UNITED STATES PATENT AND TRADEMARK OFFICE

| APPLICATION NO. | FILING DATE | FIRST NAMED INVENTOR | ATTORNEY DOCKET NO. | CONFIRMATION NO. |
|-----------------|-------------|----------------------|---------------------|------------------|
| 10/724,754 | 12/02/2003 | Etienne Galmiche | 0512-1190 | 1809 |

Office Action Summary

DETAILED ACTION

Figure A. Prior art of Schroter.

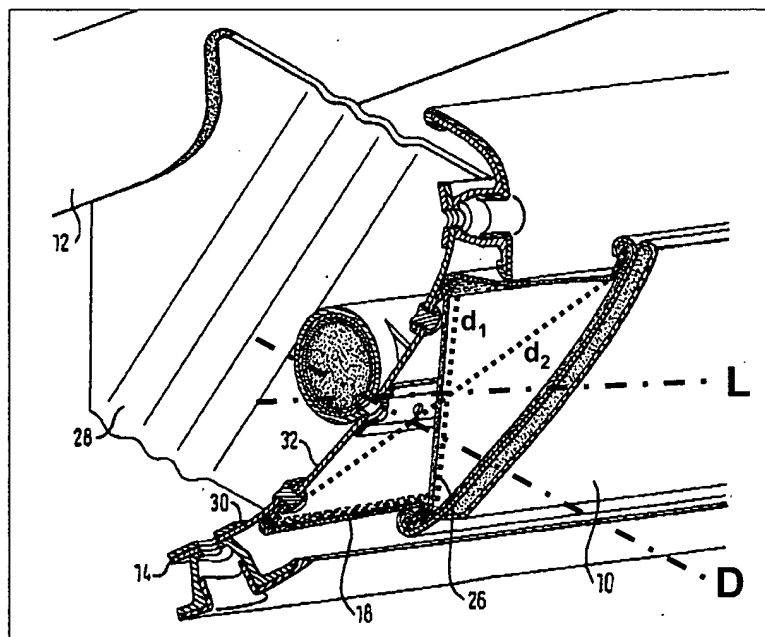
b. The side wall 18 of the structure has a first diagonal d_1 shorter than a second diagonal d_2 of the side wall so that, as the structure deploys, the side wall which is substantially taut along the first diagonal brings the structure towards the median directrix line as shown in Figure A below (column 1, line 56 – column 2, line 11) (claim 2.)

c. When the structure is in the deployed configuration, the side wall 18 extends substantially over its entire periphery along generatrices parallel to the median directrix line L as shown in Figure A below (Fig. 4) (claim 4.)

d. The median directrix line L is intended to be inclined upwards with respect to the direction of inflation D when the set of equipment is installed in a motor vehicle as shown in Figure A (Fig. 4) (claim 5.)
